GREATER LONDON HOUSE

**Planning Condition 11 discharge Design Note updated to
incorporate additional comments from planning department.
Revision 01 - 05.10.18**

Scheme Address	ASOS HQ, Greater London, Hampstead Road, Camden Town, London, NW1 7FB
Planning Reference	2018/2868/P
Application type	Condition
Size of site (as stated on application form)	1.5 ha only 0.156 is being redeveloped
Date	29/08/18
Recommendation:	Not Discharged

Drawn/Design	MS	Checked	DL	Approved	DL	Date	02/04/2017
Scales	1:100	Drawing No.	TB-LG-RW-002	Rev	P2

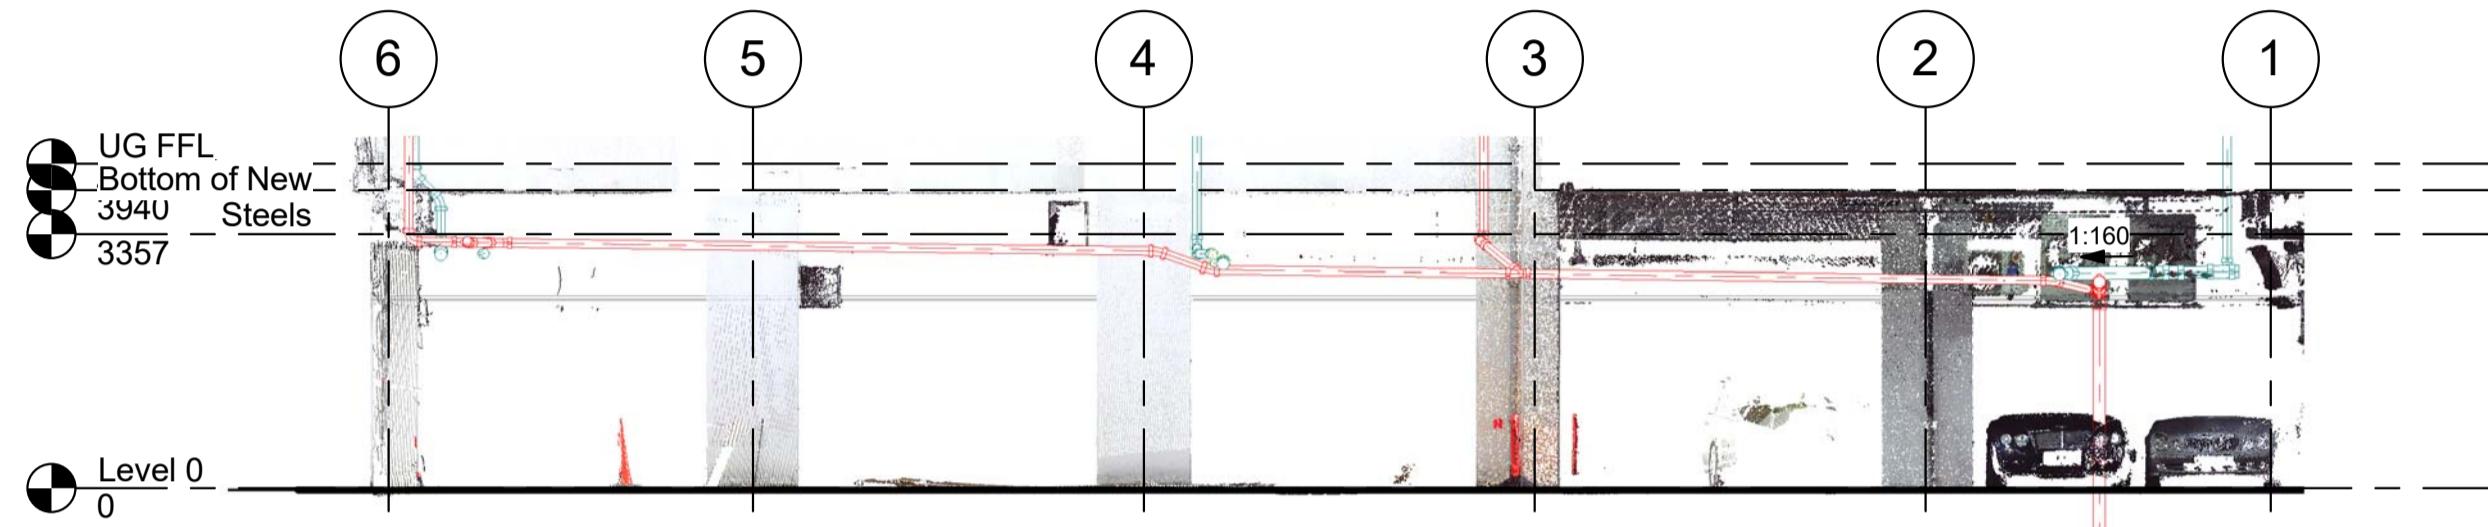
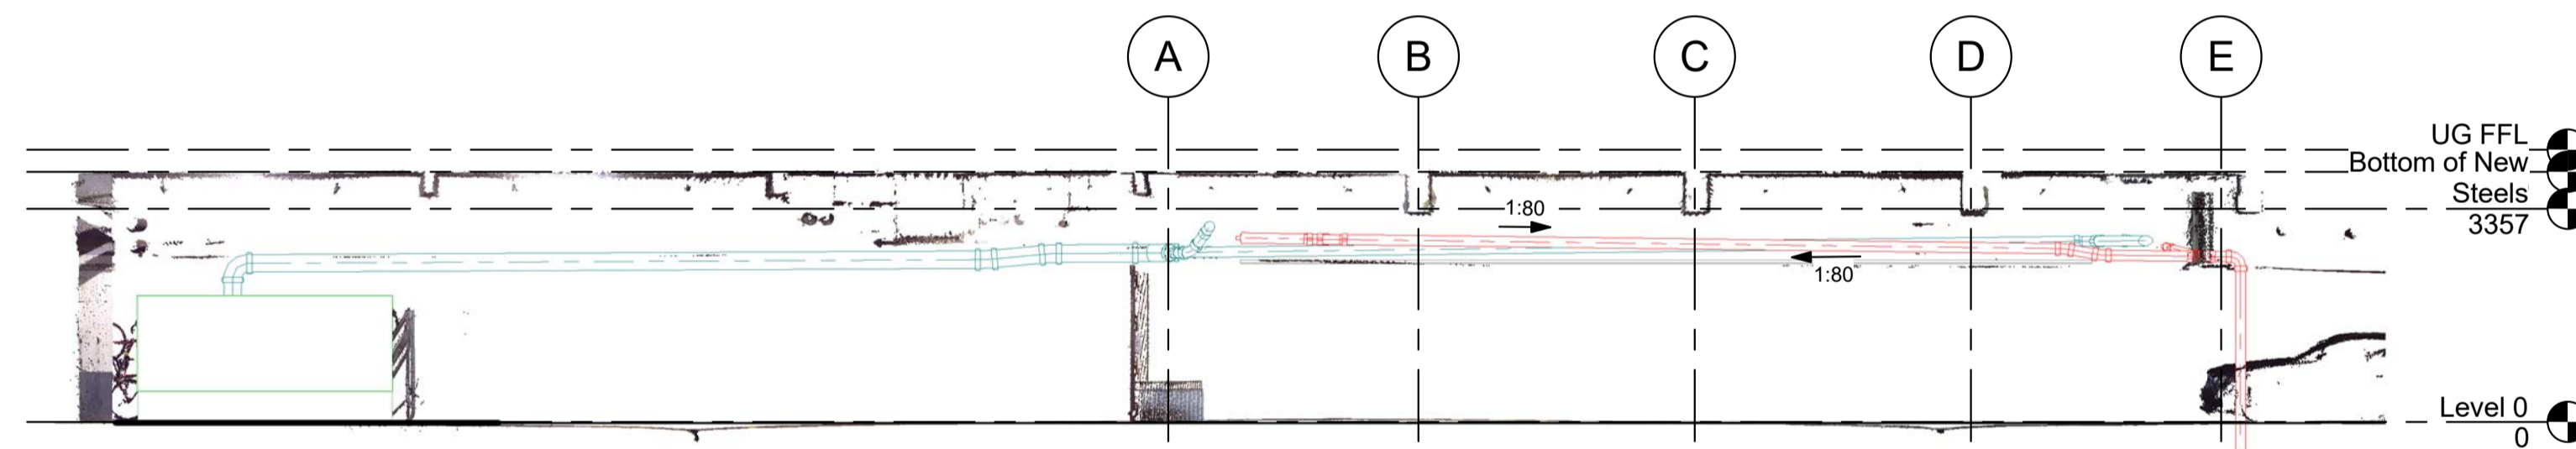
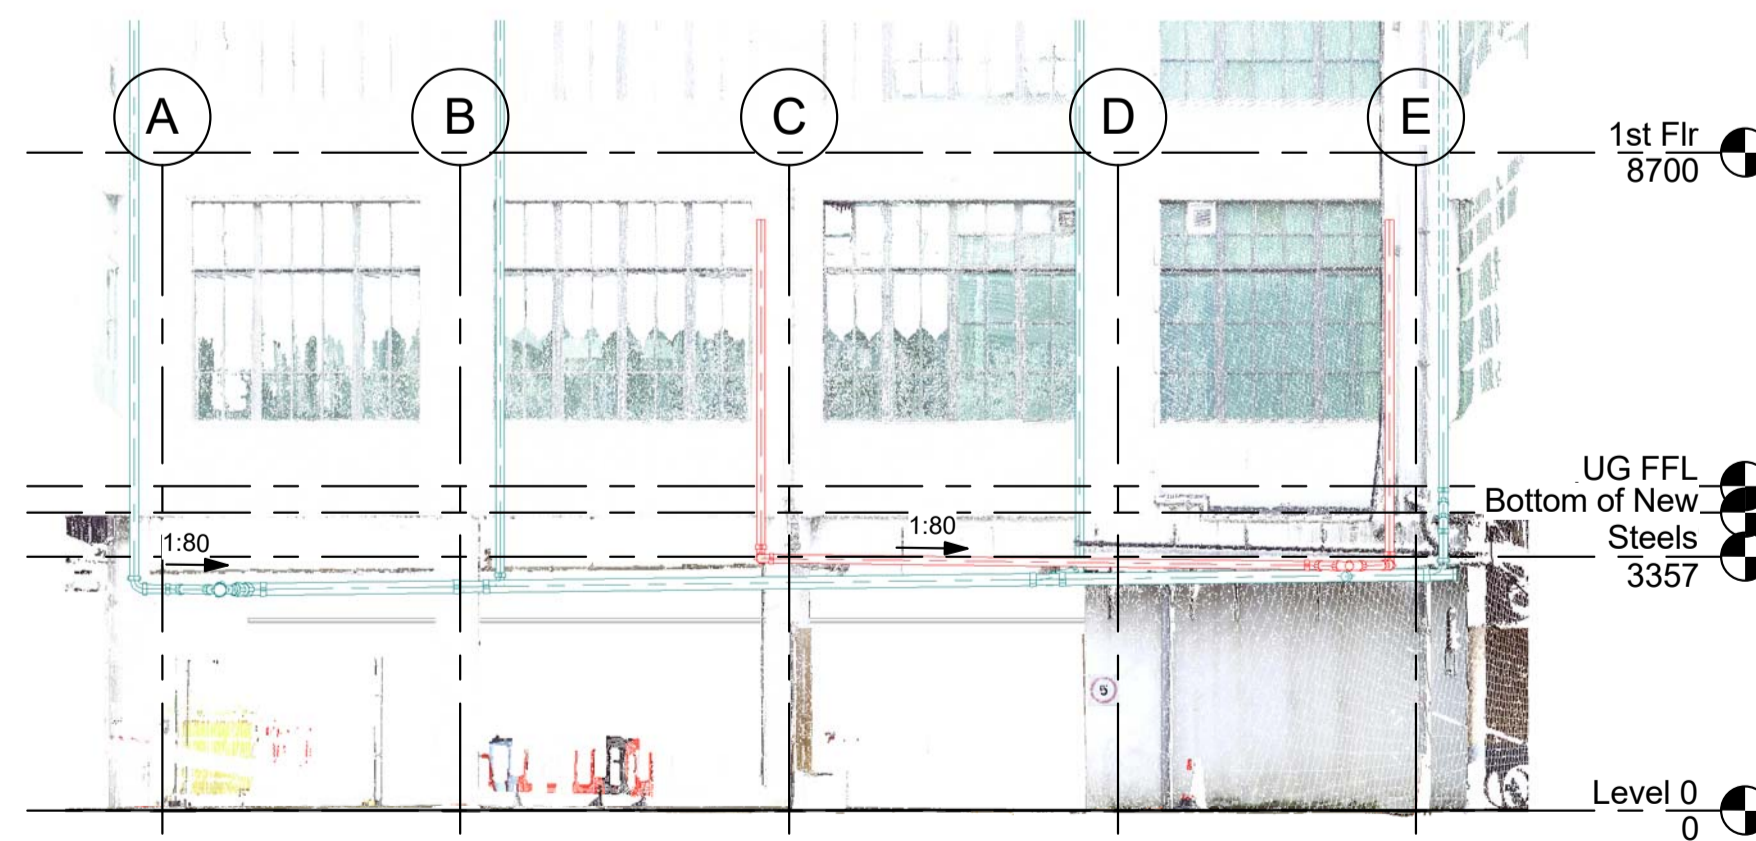
2. **Comment:** The applicant has modified their proposed strategy, so it now differs from the strategy that was previously approved. They now state that only 53 m³ of storage is required as opposed to 110 m³ as was previously stated. This volume would be provided by three attenuations tanks. The volume of the tanks are not stated on Proposed Drainage Layout (GLP, February 2016, 1607-M106-T2). However, the typical detail they provided for an attenuation tank indicates each tank would have a volume of approximately 35 m³. Furthermore, the MicroDrainage calculations they have provided for each tank do not provide clarity in regards to their volume, as they do not show a depth for the tank.

Recommendation: The applicant needs to specify and clarify the exact volume of storage that will provided as part of the proposed drainage.

There will be 3No 18m³ attenuation tanks that provide a total of 54m³ (actual requirement is 52.4m³ for the site) the calculations for the catchment area serving each tank are provided.

Spatial and existing structural constraints imposed on the drainage layout and hence the change in the tank locations and sizes. Please refer to the latest plans and sections within [Appendix B](#).

STATUS: Contract
DRAWING NUMBER: 5001_20_230

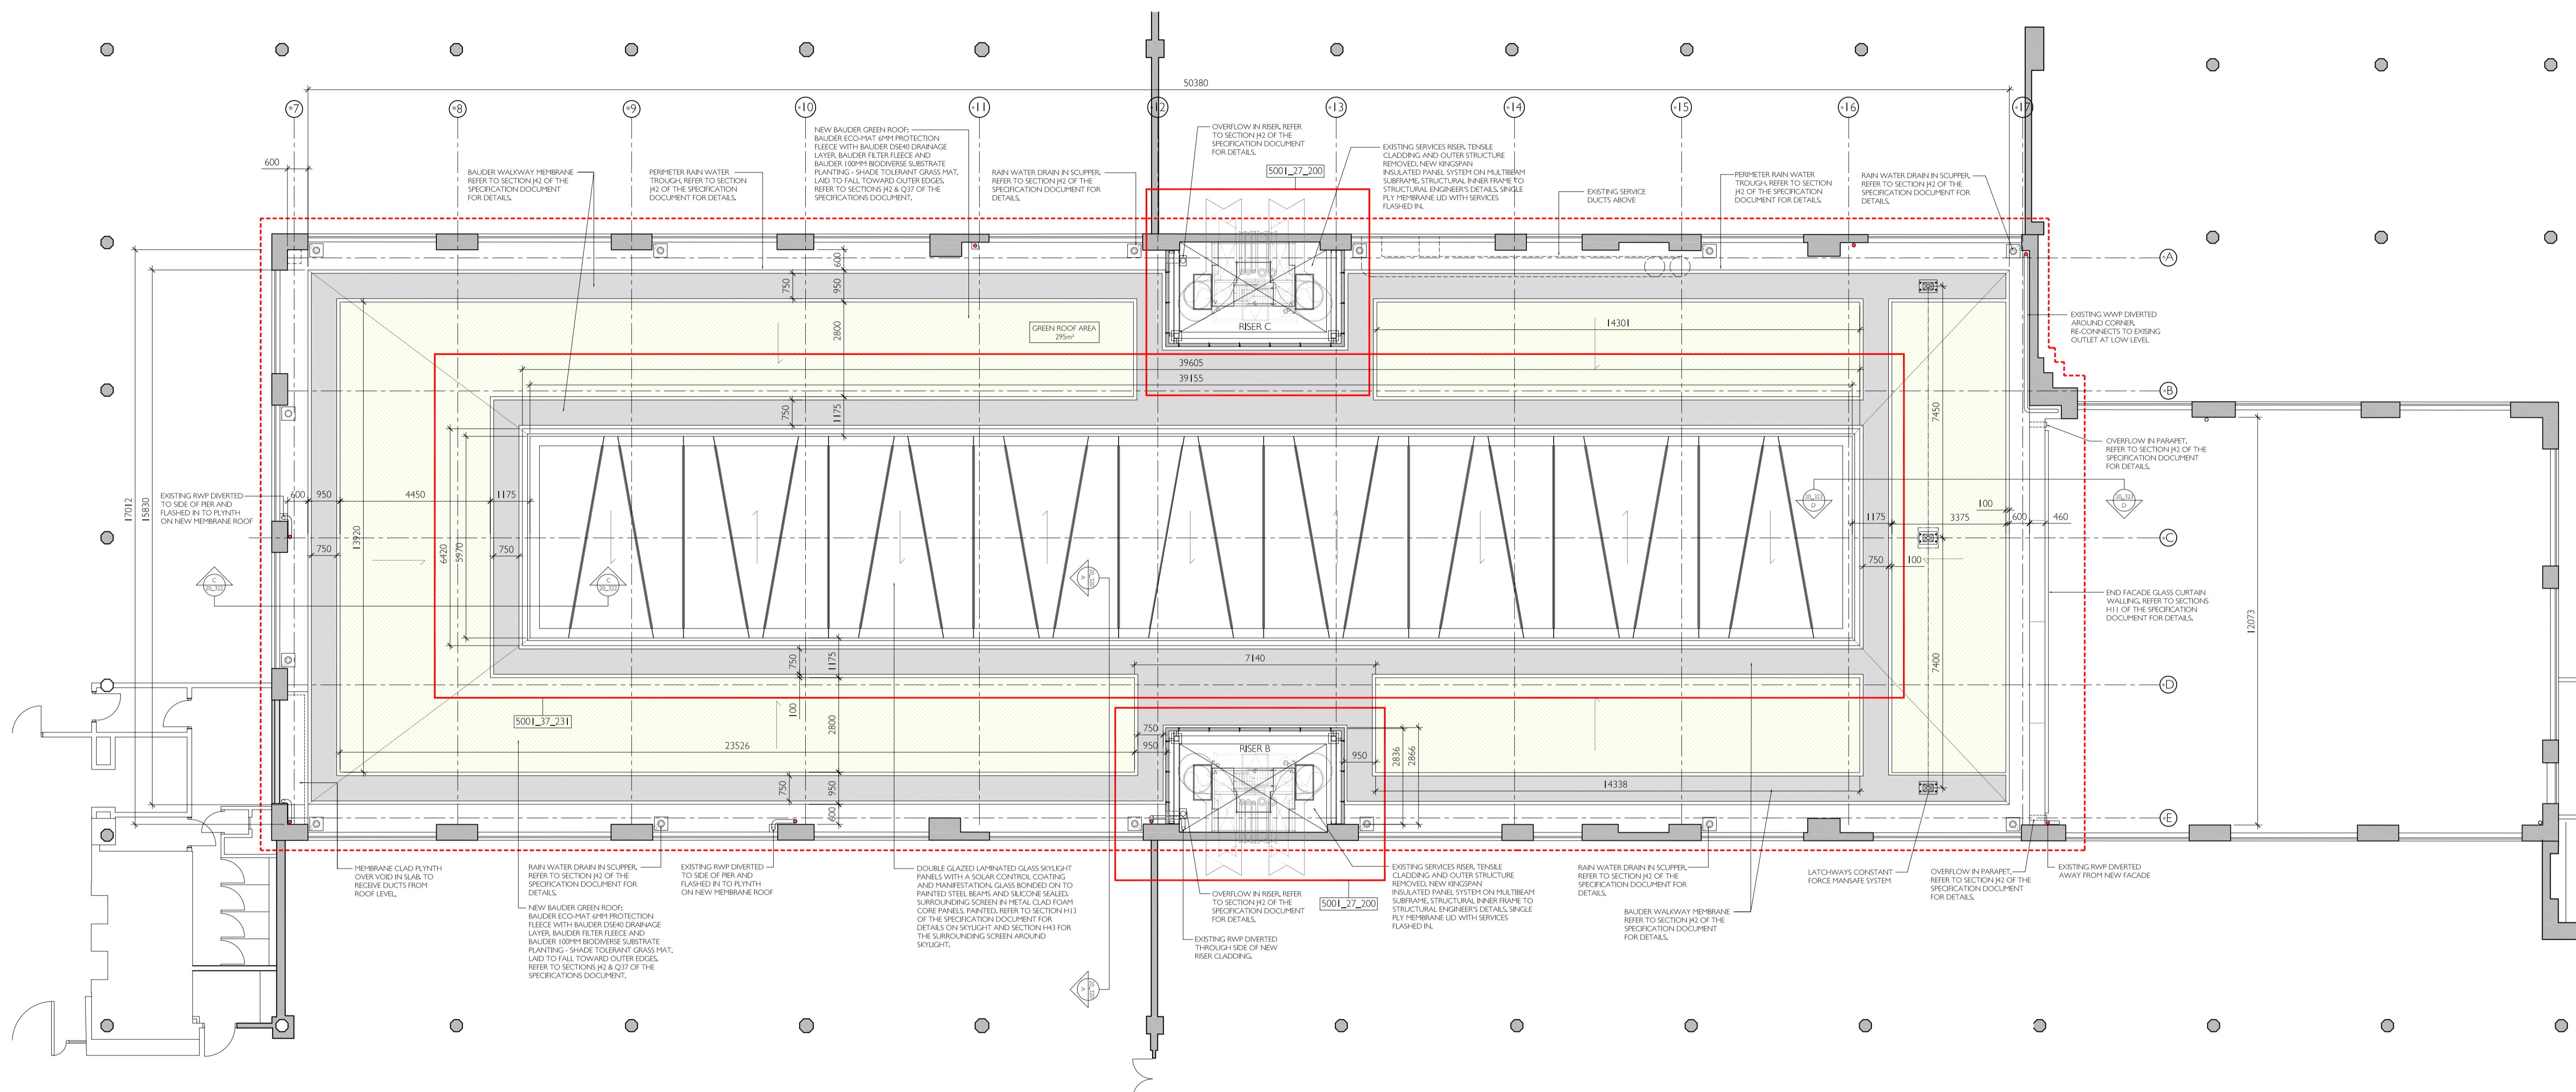
- Comment:** Within the previously approved drainage strategy, it is stated that green roofs will not be provided on site. Furthermore, green roofs are not shown on the Proposed Drainage Layout (GLP, February 2016, 1607-M106-T2). However, maintenance regime has been provided for green roofs.

Recommendation: The applicants should clarify whether green roofs will be provided on-site. If green roofs are to be provided, their location needs to be shown the Proposed Drainage Layout.

The project is not completed (ref: Application Form), suggesting that the green roof elements may not yet be implemented. Proof that they are installed will address the planning officers concerns.

Latest Architectural roof plan attached with the extent of the green roof to be incorporated on this development, please refer to the plan drawings within [Appendix D](#).

The Green roof area installation is pending on site, we anticipate from engagement with the main build contractor that this will be completed towards the end of November 2018, GLP shall submit further information in due course in respect of this matter.
